Item ID: D206-642-341BL Accept ***N900040100*** Setup Start ***NS1***
Revision ID: Stop ***NS2***
Item Name: Replacement Skidtube (Fits LH or RH)
Start Date: 5/17/2017 Start Qty: 1.00 ***1*** Cust Item ID:
Required Date: 5/30/2017 Req'd Qty: 1.00 ***1*** Customer:
Reference: SCHEDULED/C

DESIGN	DS	DART AEROSPACE USA, INC	
DRAWN	AJS	PORT HADLOCK, WA	
CHECKED		DRAWING NO.	REV. F
MFG. APPR.		D2650	SHEET 6 OF 6
APPROVED		TITLE	SCALE
DE APPR.		206/407 SKIDTUBE ASSEMBLIES	NTS
DATE	08.08.08	COPYRIGHT © 1997 BY DART AEROSPACE USA, INC THIS DOCUMENT IS PRIVATE AND CONFIDENTIAL, AND IS SUPPLIED ON THE EXPRESS CONDITION THAT IT IS NOT TO BE USED FOR ANY PURPOSE OR COPIED OR COMMUNICATED TO ANY OTHER PERSON WITHOUT WRITTEN PERMISSION FROM DART AEROSPACE USA, INC.

DRAWING NO. D2650	TITLE 206/407 SKIDTUBE ASSEMBLIES	REV. F	DART AEROSPACE LTD ENGINEERING ORDER		D.E.O. NO. D2650-F-1	SHEET NO. SHEET 1 OF 1	SCALE NTS
DRAWN <i>AP</i>	CHECKED <i>A.P.</i>	MFG. APPR. <i>AA</i>	APPROVED <i>##</i>		DE APPR. <i>##</i>		
DATE 12.10.12	DATE 12.10.22	DATE 12.10.22	DATE 12.10.22		DATE 12.10.22

DETAIL G

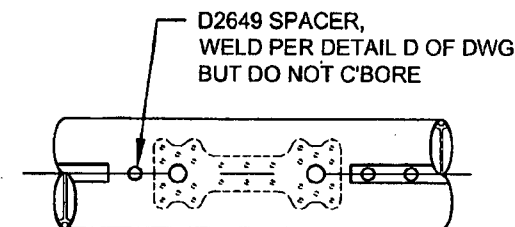
CHANGE C'BORED WELDED CROSSBOLT SPACERS TO SWAGED SPACERS

ADD DETAIL G BELOW, WHICH IS THE SAME SECTION VIEW AS DETAIL D OF DWG.

C'BORED HOLES ARE NOW SWAGED PER DETAIL G BELOW. FOR THE Ø0.375 HOLE THAT IS NOT C'BORED, WELD PER DETAIL D OF DWG (SEE AMENDED DETAIL B FOR REFERENCE).
